A. INTRODUCTION

The applicant, Durst Development L.L.C., has proposed revisions to the proposed project analyzed in this Final Supplemental Environmental Impact Statement (FSEIS), and the City Planning Commission (CPC) is contemplating certain modifications to the proposed project (the “proposed modifications”), including:

CPC PROPOSED MODIFICATIONS

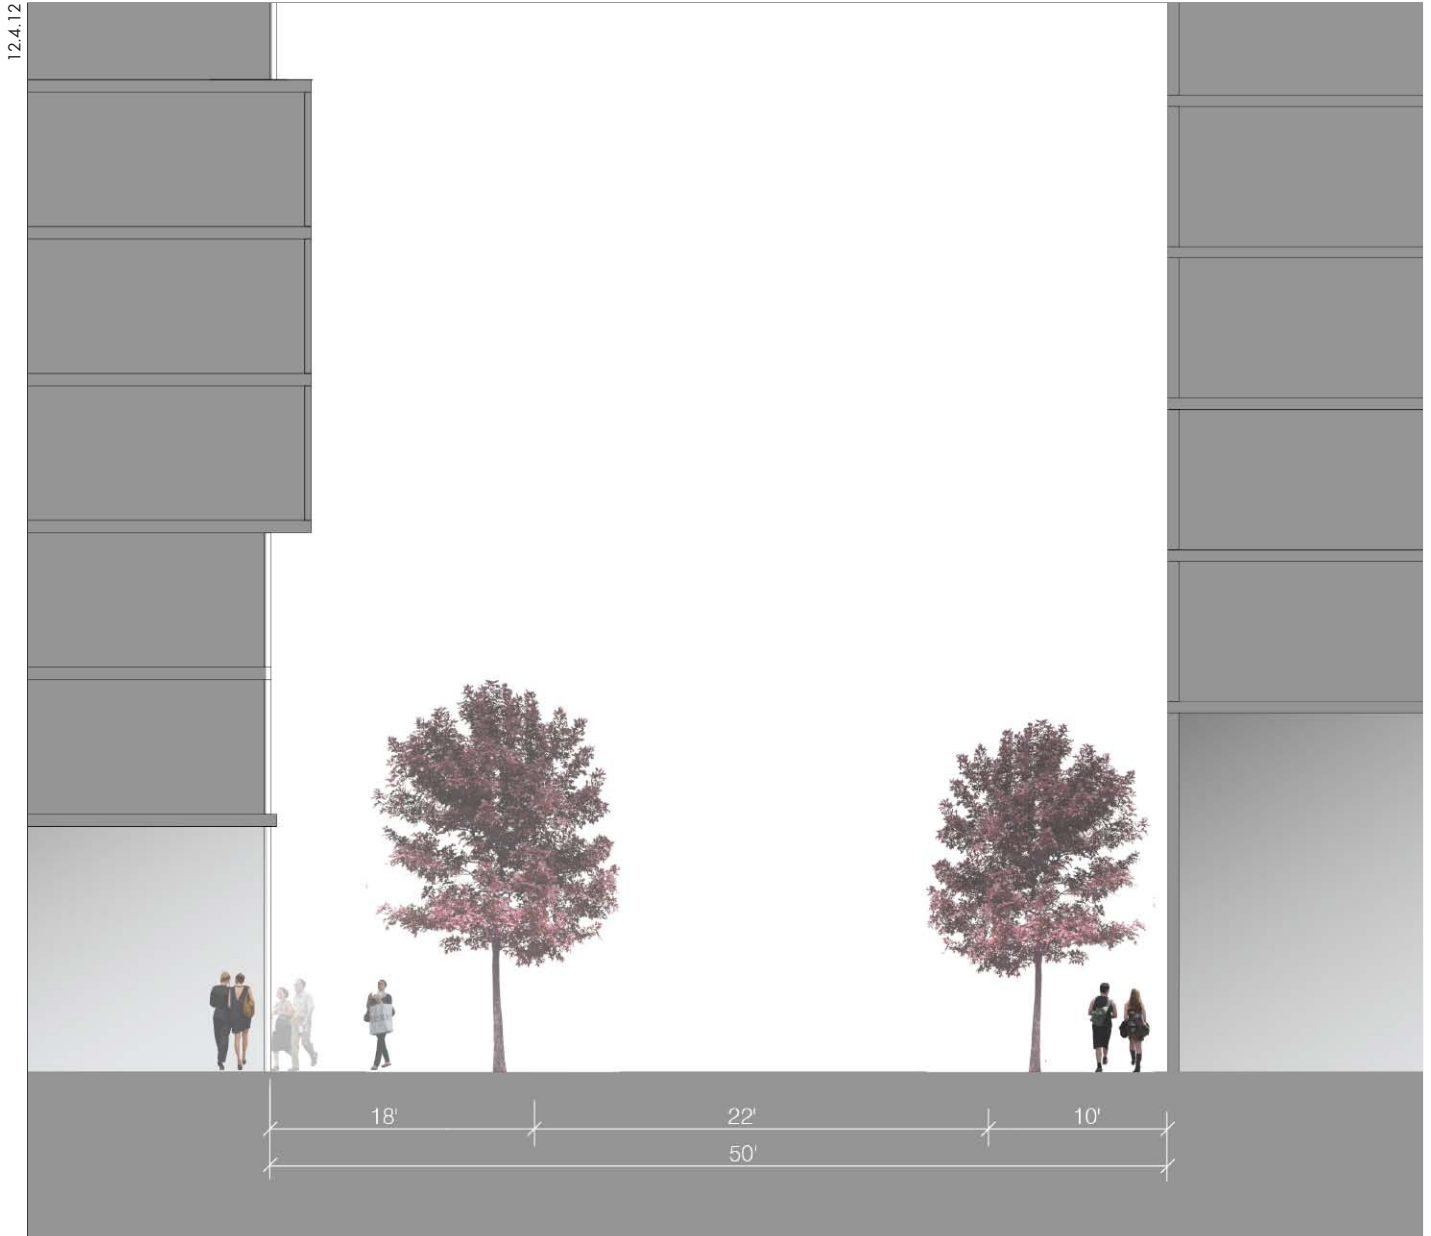
- Narrow the width of the midblock access drive from 25 feet to 22 feet, and widen the adjacent sidewalks accordingly, resulting in an approximately 18 foot wide pedestrian path on the western edge and an approximately 10 foot pedestrian path on the eastern edge, as shown in **Figure 21-2**. The widened sidewalk would include benches to provide seating, and trees and planters that would flank the edges of the pedestrian walkway next to the vehicle drive through. The accessway would have a uniform elevation throughout (i.e., no sidewalk curbs) and the paving treatment would be continued into the lobby of the building on projected development site 1.

- Include retail frontage at the northeast portion of projected development site 1 adjacent to the midblock access drive along West 58th Street.
- Require a minimum of three establishments in projected development site 1 along West 57th Street.

- Require street level façade transparency on West 57th Street.
- Commit to “wrap-around” the Twelfth Avenue establishment to approximately 80 feet east along the West 58th Street frontage.
